# Access Compliance Report

## Public Rights-of-Way

Intersection ID: 14386	Main Street: LILLINGTON_AV	Cross Street: LUTHER_ST	Location:	N
ADA ID: 0AE476606F49	Ramp Type: PerpDiag	Initial Pass/Fail: Fail	Overall Compliance: No	Severity Score: 35

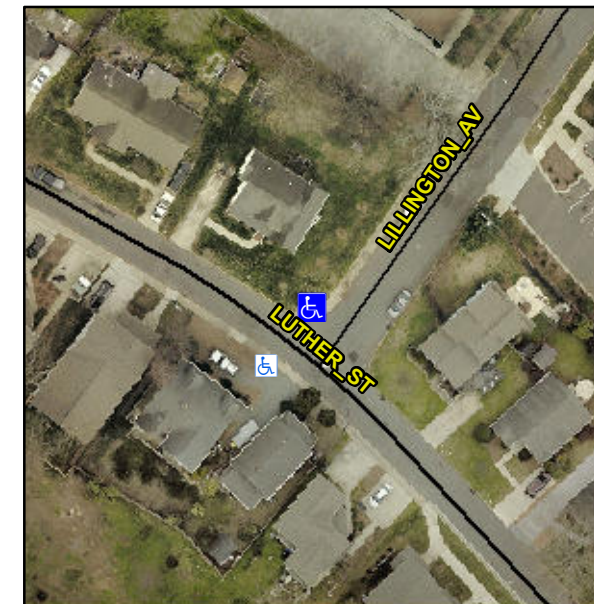
**R304.5.1, R304.2.2, R304.5.3**

Compliance	Description	Data	Compliance	Description	Data
N/A	Ramp Length (in)	63.0	No	Ramp Slope (%)	14.1
No	Ramp Width (in)	45.0	No	Ramp XSlope (%)	2.9
N/A	Flare Type LT	N/A	N/A	Flare Type RT	N/A
N/A	Flare Slope LT (%)	N/A	N/A	Flare Slope RT (%)	N/A
N/A	Flare Traversable LT?	N/A	N/A	Flare Traversable RT?	N/A
N/A	Landing Length (in)	N/A	N/A	DWS Provided?	N/A
N/A	Landing Width (in)	N/A	N/A	DWS Contrast?	N/A
N/A	Landing Slope (%)	N/A	N/A	DWS Length (in)	N/A
N/A	Landing X Slope (%)	N/A	N/A	DWS Full Width?	N/A
N/A	Landing Curb? (Y/N)	N/A	N/A	DWS Offset (in)	N/A
N/A	Shared Landing?	N/A			
N/A	Gutter Ponding?	N/A	N/A	Gutter Slope (%)	N/A
N/A	Gutter Lip Ht (in)	N/A	N/A	Gutter X Slope (%)	N/A
N/A	Painted X Walk1?	No	N/A	Painted X Walk2?	No
	X Walk 1 Direction	To SW		X Walk 2 Direction	To SE
N/A	X Walk 1 Width (in)	N/A	N/A	X Walk 2 Width (in)	N/A
	X Walk 1 Slope (%)	2.2		X Walk 2 Slope (%)	1.6
	X Walk 1 X Slope (%)	0.8		X Walk 2 X Slope (%)	3.5

**Remove & Replace Curb Ramp With Two New Directional Ramps or Equivalent.**
